HINCKLEY WEST DEVELOPMENT

PLANNING APPLICATION REF: 23/0573/FUL

RESPONSE TO LEICESTERSHIRE COUNTY COUNCIL COMMENTS (ISSUED 22/12/23)

Figure 6.1: Toucan Crossing Location Plan

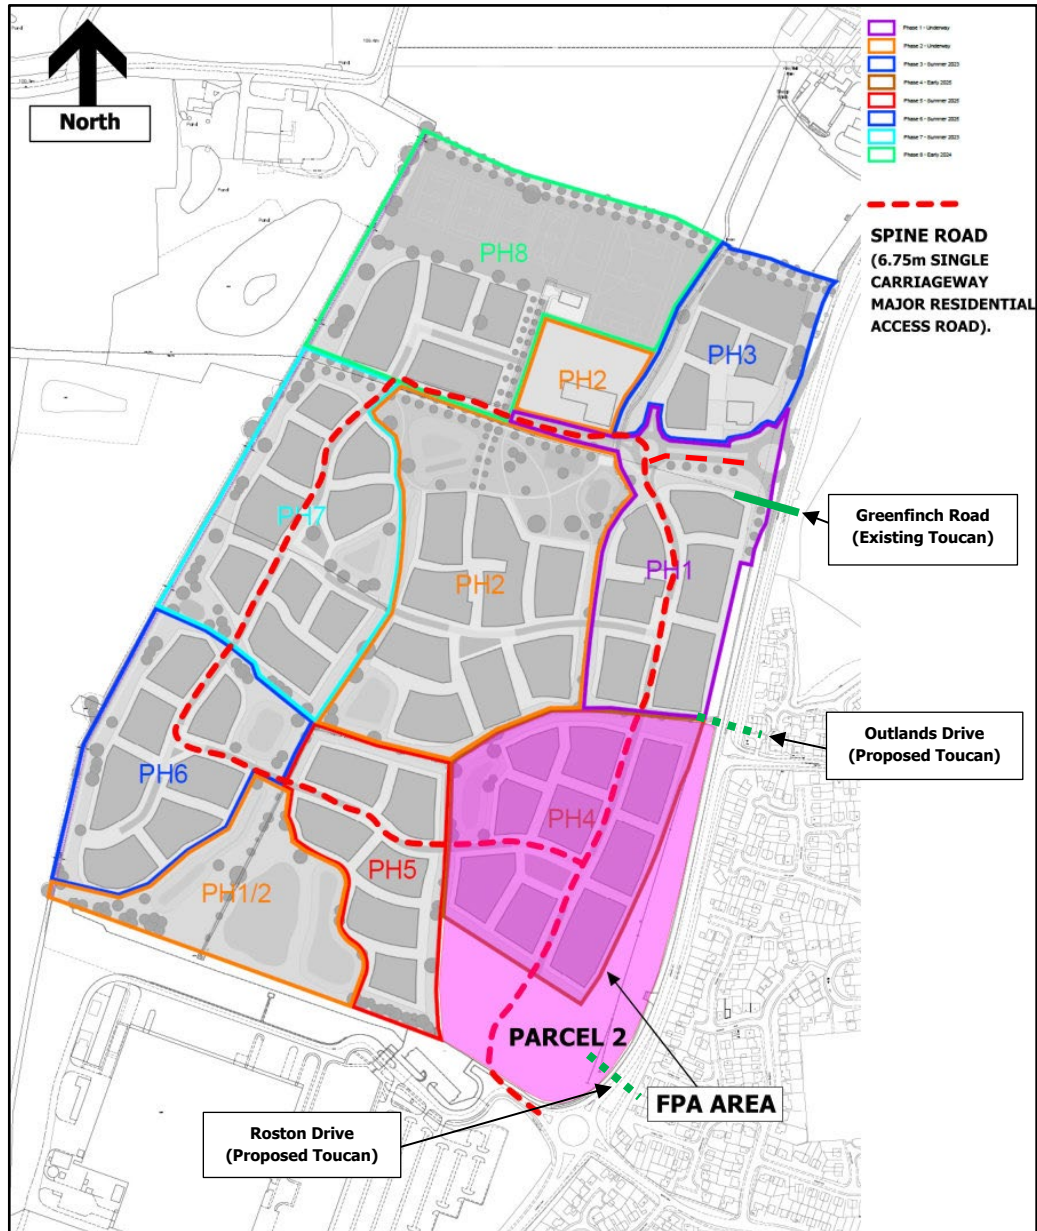
- 6.1.4 **Figure 6.1** below shows the location of the Hollycroft Grange development and the approximate location of the proposed Outlands Drive crossing, together with the adjacent crossing points at Greenfinch Road and Roston Drive.

PROJECT NO.	DRAWING NO.	REV
C21021	DR101	A

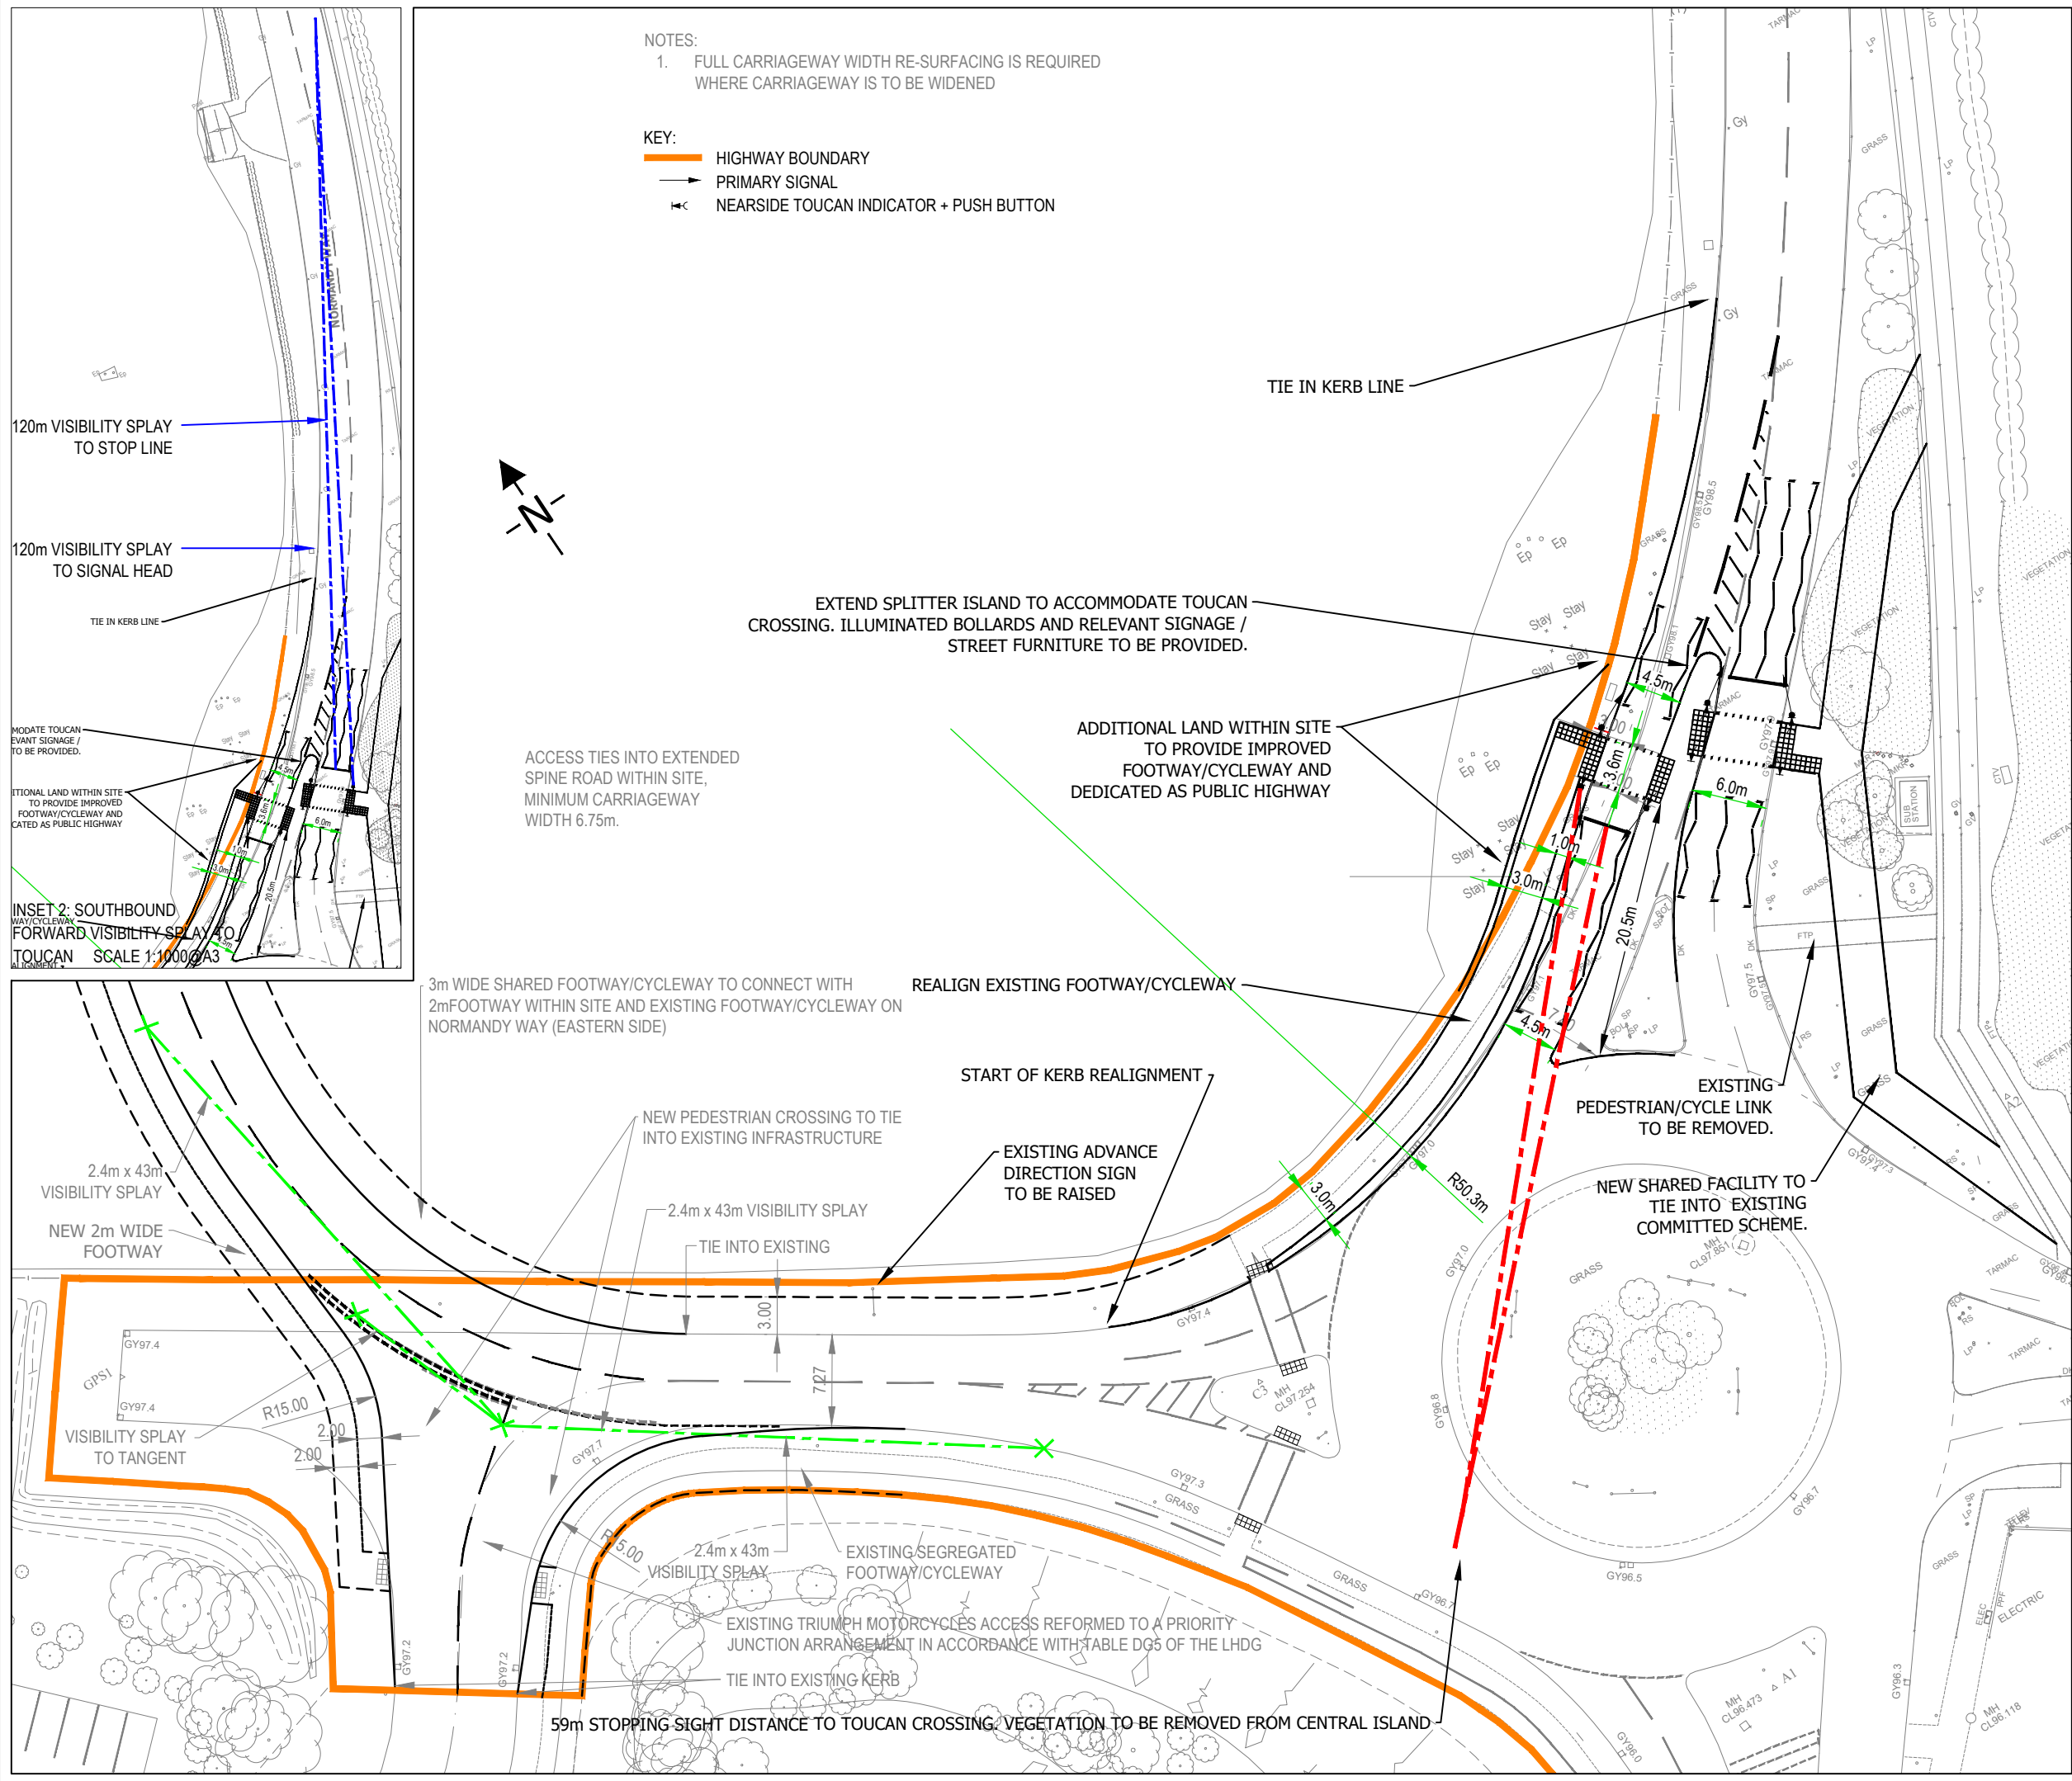
LCC Comment No. 1	Design Team Response
A traffic capacity assessment would be required for the proposed junction layout for the LHA to review, and also to inform the design layout requirements for any queuing length provision, ensuring traffic does not block the roundabout etc.	Capacity assessments of both the A47/Roston Drive Roundabout and the Triumph Motorcycles access are presented in the submitted TA. The former has been updated to reflect use of the lower trip generation rates set out in TN3 and design changes requested in LCC's response. These revised assessments are provided under the heading <i>Junction Capacity Assessments</i> on pages 13 to 16 below. The revised access proposals are shown on Drawing C21021/DR101 (Page 20 onwards).

LCC Comment No. 2	Design Team Response
The tactile paving arrangements appears excessive, the "tails" could be removed and a layout in keeping with Figure 11 of "Guidance on the Use of Tactile Paving Surfaces" proposed instead.	The tactile paving proposals shown on Drawing C21021/DR101 (Page 20 onwards) have been designed in accordance with the resource quoted by LCC. The layout requirements will be reviewed and agreed at detailed design stage.

LCC Comment No. 3	Design Team Response
The existing footway link between the splitter island and footway/cycleway should be identified.	A note to this effect has been included on Drawing C21021/DR101 (Page 20 onwards).

LCC Comment No. 4	Design Team Response
In accordance with Table DG5 of the LHDG the LHA would advise the applicant to design the access to the Triumph factory as a major industrial access. This could alleviate the issues identified with the swept path analysis below.	The junction of the factory access with the proposed Spine Road has been amended to provide 15m corner radii and exit/entry tapers in accordance with LHDG Table DG5. Vehicle swept path analysis is shown on Drawing C21021/DR102 (Page 20 onwards) and demonstrates that the design vehicle (articulated HGV) can be accommodated.

LCC Comment No. 5	Design Team Response
Signal heads should be shown on the drawing with dimensions demonstrating that the design criteria required by LTN1/20 can be adhered to.	Traffic signal heads at the <i>Toucan</i> crossing are shown on Drawing C21021/DR101 (Page 20 onwards) in accordance with the relevant guidance.

LCC Comment No. 6	Design Team Response
The changes to the roundabout geometry are minor and acceptable however the roundabout exit width leading towards the proposed crossing is considerably below the required 7 to 7.5m stated in DMRB CD116.	The <i>Toucan</i> crossing has been placed within the roundabout northern splitter island to follow the desire line along the north side of Roston Drive. To minimise crossing distances, the northbound exit width has been reduced by widening the splitter island. No road safety issues relating to this proposal were raised in the Stage 1 RSA. It is noted that whilst there is a reduction below recommended standards in terms of exit width, LCC accepts the amendments to the roundabout's geometry (see Appendix B). An alternative option would be to relocate the Toucan crossing north of the roundabout exit. No modifications to the existing northbound exit would then be required and the crossing would be positioned where the whole carriageway can be crossed in a single movement. However, it is considered that the current <i>Toucan</i> location would minimise walking distances and is currently the preferred arrangement in terms of encouraging modal shift.

LCC Comment No. 7	Design Team Response
Visibility splays for the proposed access should be based on measured 85th percentile speeds and not the signed speed limit. The splays should also be to both the left and to the right of the junction.	The proposed access is an extension of the existing cul-de-sac that leads only into Triumph Motorcycles access, located just 50m from the Roston Drive roundabout exit. Any measurements of vehicle speeds on this existing link would be unrepresentative of the proposed future road layout, which has been designed to limit vehicle speeds to 30mph. Visibility splays of 2.4m x 43m are shown to the left and right of the proposed Triumph Motorcycles access on Drawing C21021/DR101 (Page 20 onwards).

LCC Comment No. 8	Design Team Response
As the access is located on the outside of a horizontal bend, an additional visibility area ought to be shown to a point tangential to the nearer edge of the main road carriageway, as per DMRB CD123 Figure 3.9.	This has been shown on Drawing C21021/DR101 (Page 20 onwards).

LCC Comment No. 9	Design Team Response
Where the existing splitter island is shown to be widened there are currently kick over arrows. What provision has been made to ensure vehicles exiting the roundabout do not collide with the widened splitter island?	The existing kick-over arrows will be removed. Any additional road markings required to ensure satisfactory lane discipline, such as upstream entry lane arrows or spiral lane markings on the circulatory carriageway, will be agreed at detailed design stage.

LCC Comment No. 10	Design Team Response
Whilst visibility splays and Stopping Sight Distances (SSD) should be acceptable as it is an existing roundabout, the LHA require confirmation that the SSD for the traffic signal heads for vehicles exiting the roundabout is sufficient. These should be based on measured 85 th percentile speeds.	Measured 85th percentile speeds are reported in Table 3.1 of the TA, as follows: • South of Roston Drive, northbound: 34mph • North of Roston Drive, southbound: 43mph Table DG4 of the LHDG requires SSD of 59m for vehicle speeds of 31mph to 35mph. Northbound exit visibility splays of 59m are shown on Drawing C21021/DR101 (Page 20 onwards). For the southbound approach to the <i>Toucan</i> crossing, a SSD of 120m would be provided to accommodate measured 85th percentile speeds in the range 41mph to 44mph, as required by Table DG4 of the LHDG. As stated in the Stage 1 RSA Response Report, any existing vegetation within the highway verge that could obstruct visibility splays would be reduced.

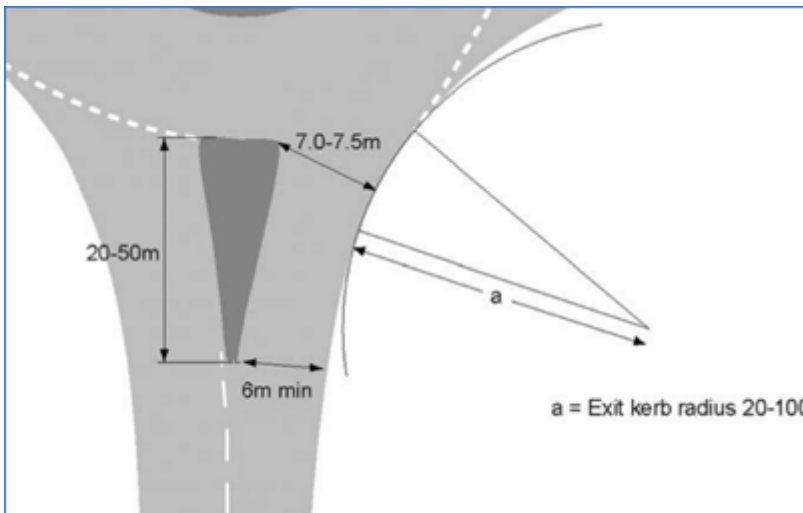
His major concern with the roundabout changes was that the exit width was only 4.5m as shown below,

whereas DMRB CD 116 clause 3.28.2 states that the exit width should be between 7.0 and 7.5m

Figure 1: Padge Hall Farm – Dodwells Roundabout Mitigation Scheme (Extract from Drawing 1839-DR-007 P5)

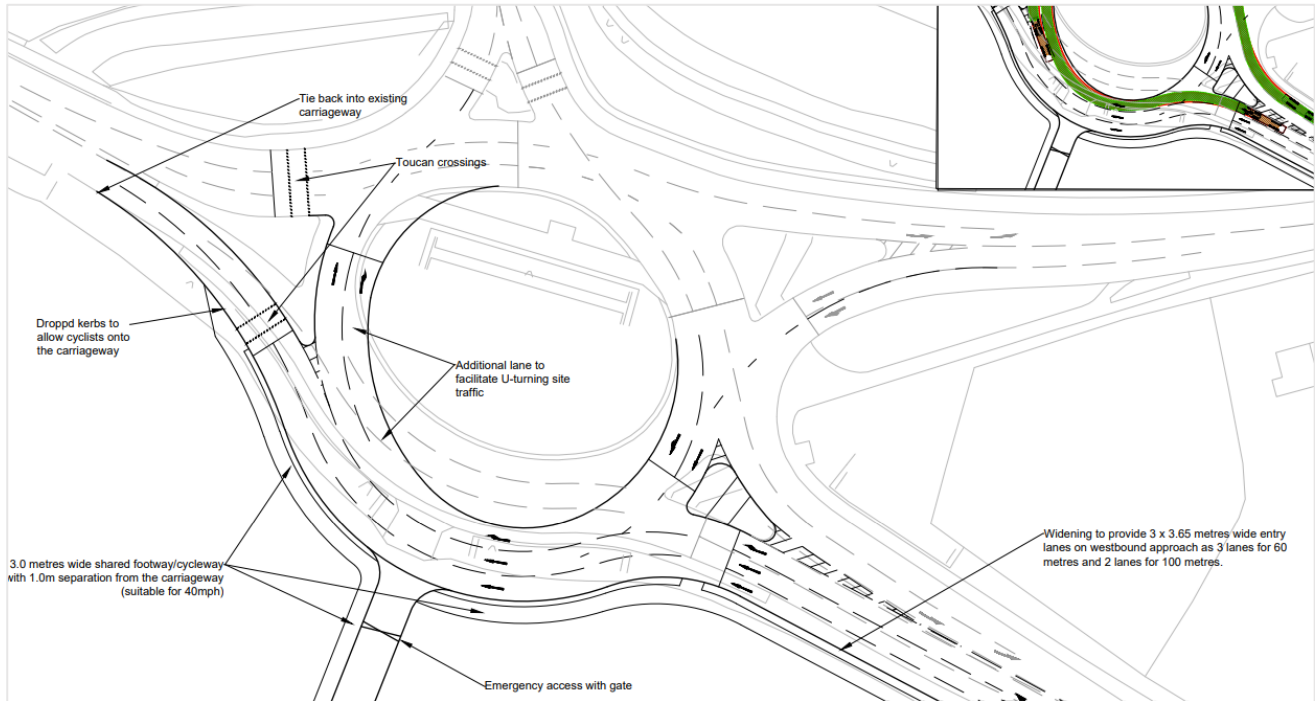
- 5.2.4 An extract of this drawing is shown in Figure 1.
